Description: Engine/Transmission Driveability Issues

Vehicles: Windstar, Freestar, Monterey

V229 PCM water intrusion

Water stain on Blue
Freestar.j...

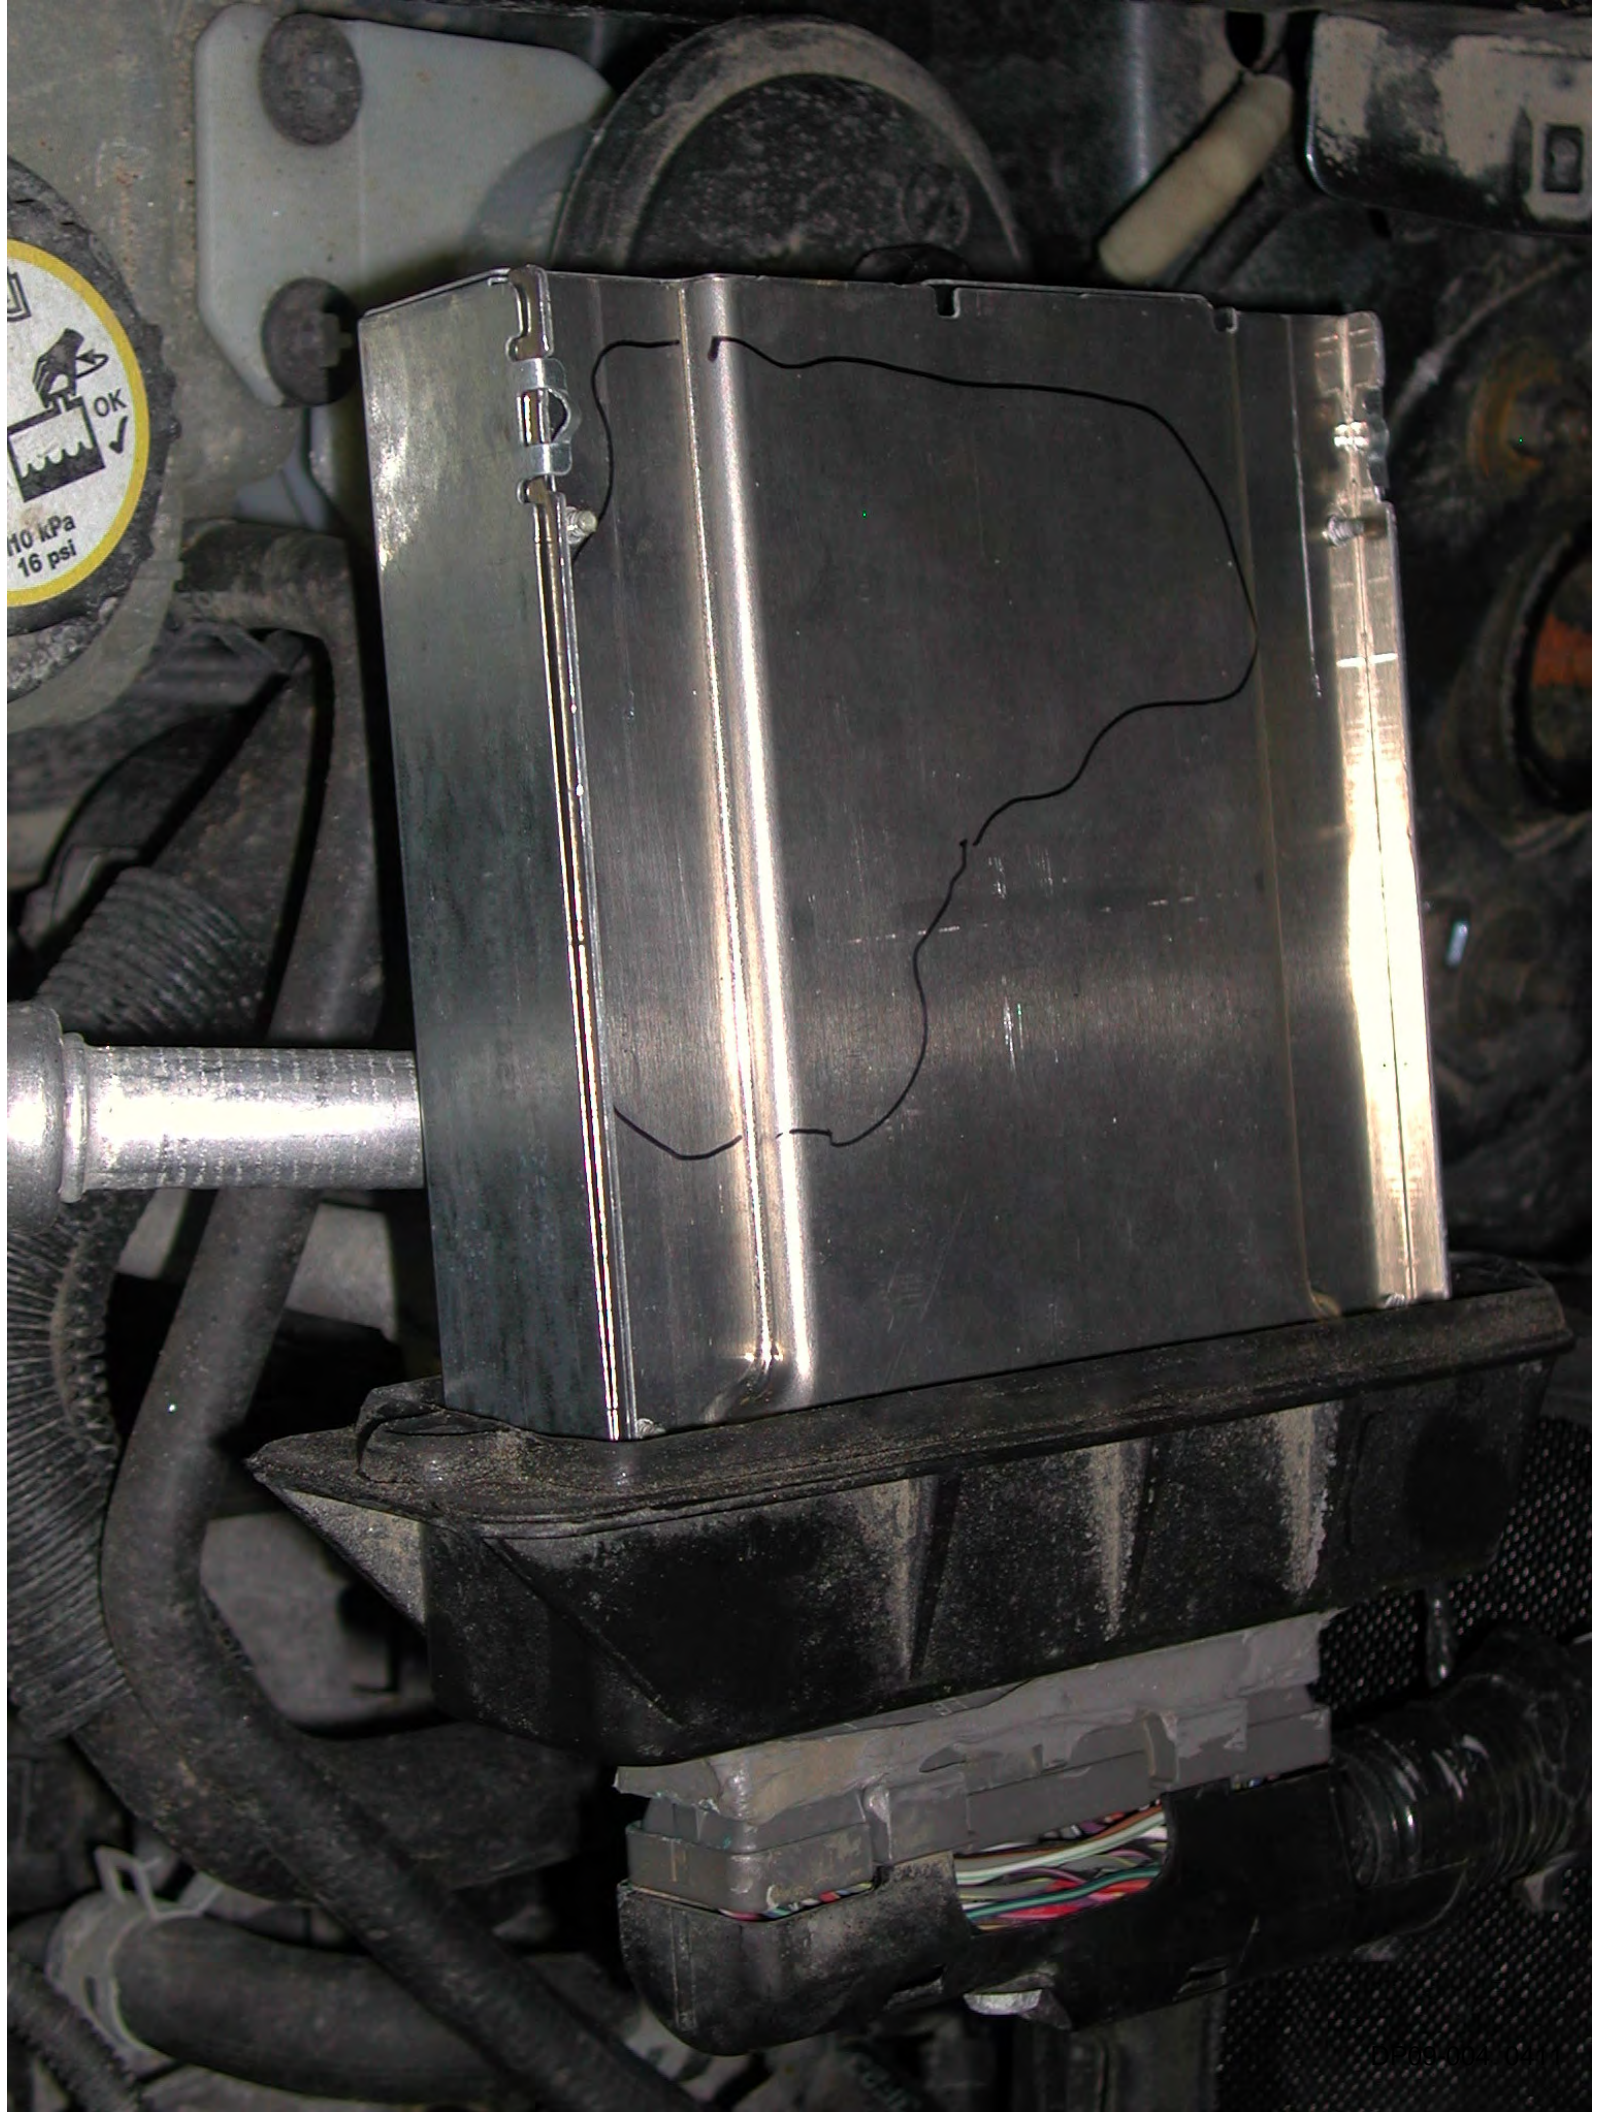
Since this unit was only in service for several months, the stain would not be too pronounced. Conversely, the stain on the PCM cover of the other PCM that I sent out earlier, was in service for over a year, so it had pronounced staining.

I have outlined the suspected stain area with black magic marker, and have attached the picture below. .

Brian suggests that you reassemble the Freestar, ship it over to the pilot plant, and have them install video cameras to run water intrusion testing, just like he did on the DEW98.

WIPER PLENUM SEAL

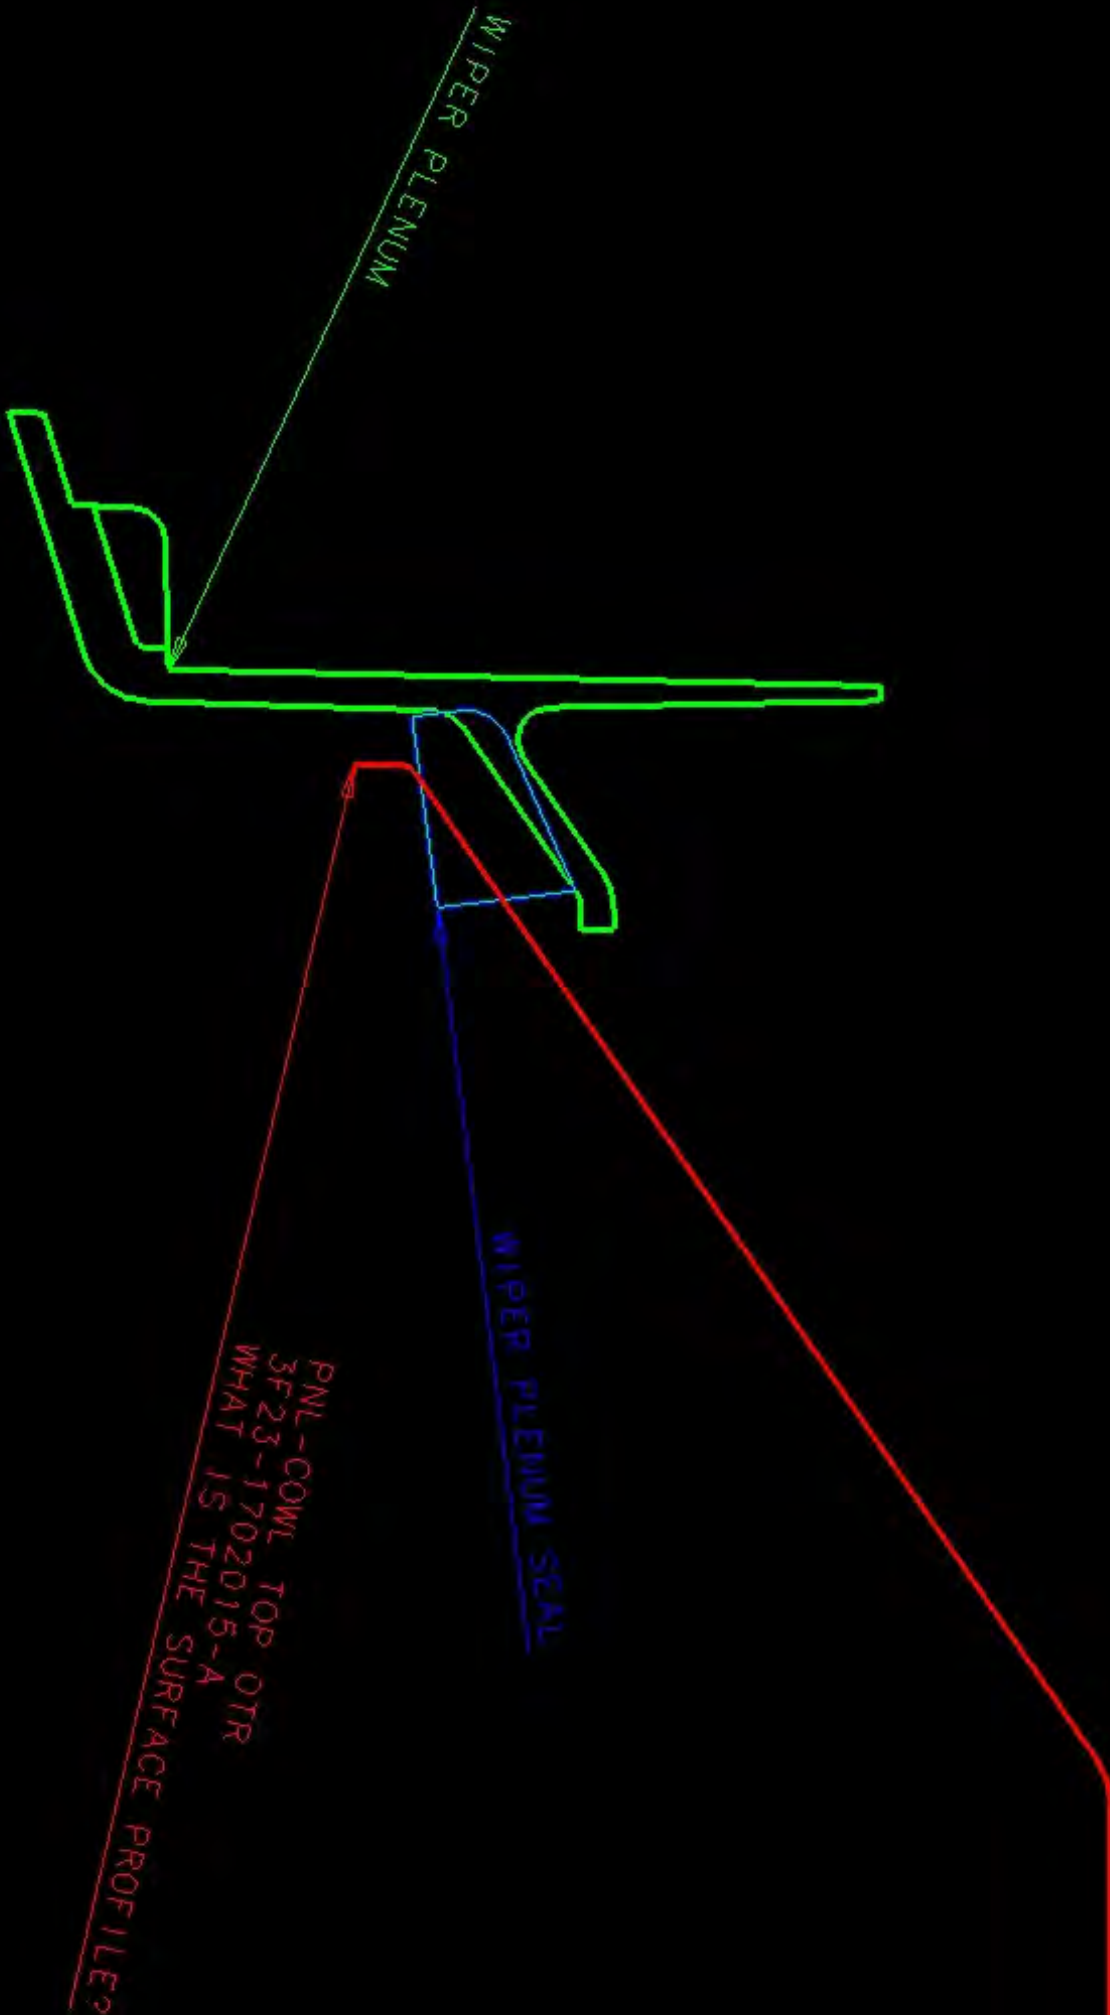
Oakville is having an issue with water intrusion into the PCM and Transmission. Valeo has been asked to investigate the sealing between the wiper plenum seal and the panel cowl top outer sheet metal. See attached jpg file.

One of the task we are asked to do is to stack up the tolerance to see what is the worst case is for compression. Can you find out for me what is the surface profile tolerance for the PNL-COWL TOP OTR 3F23-1702015-A? (See attached file: plenum_seal.jpg)

PNL-COWL TOP OTR
3F23-1702015-A
WHAT IS THE SURFACE PROFILE?

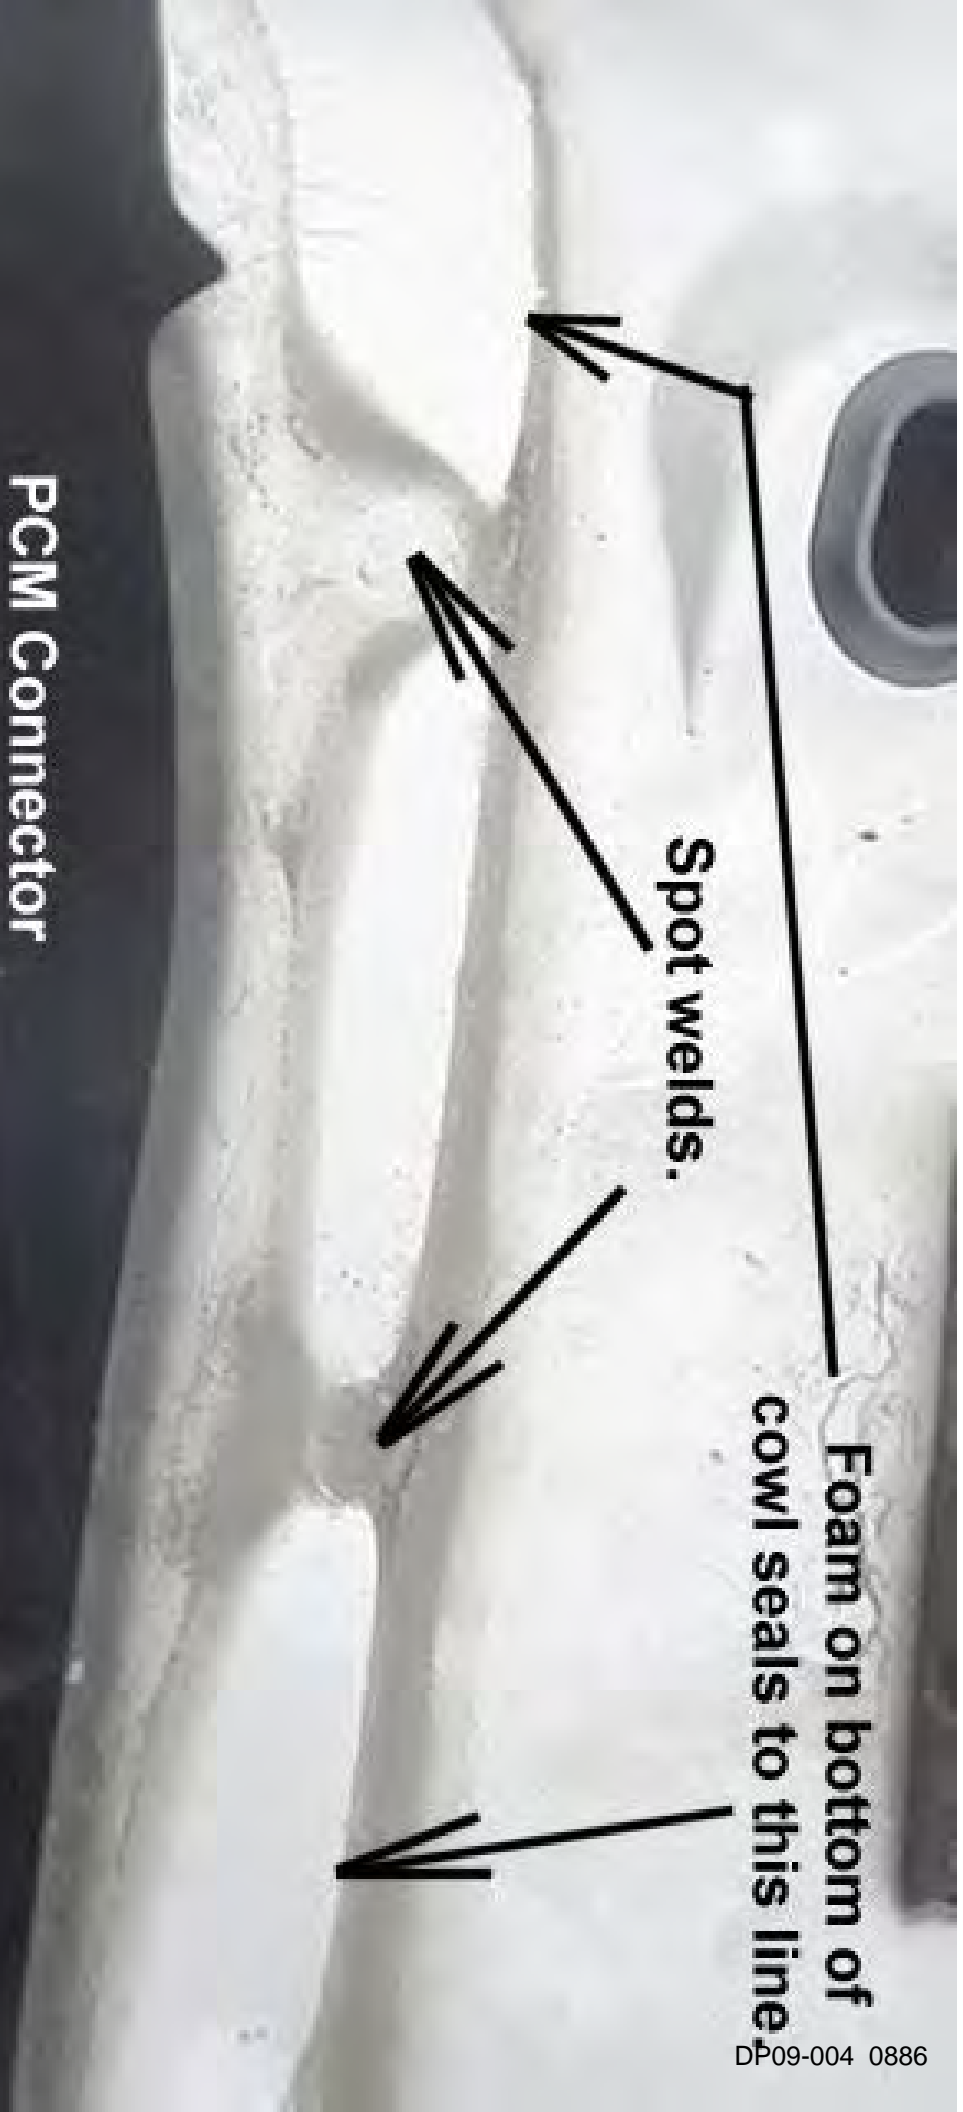
Foam on bottom of
cowl seals to this line.
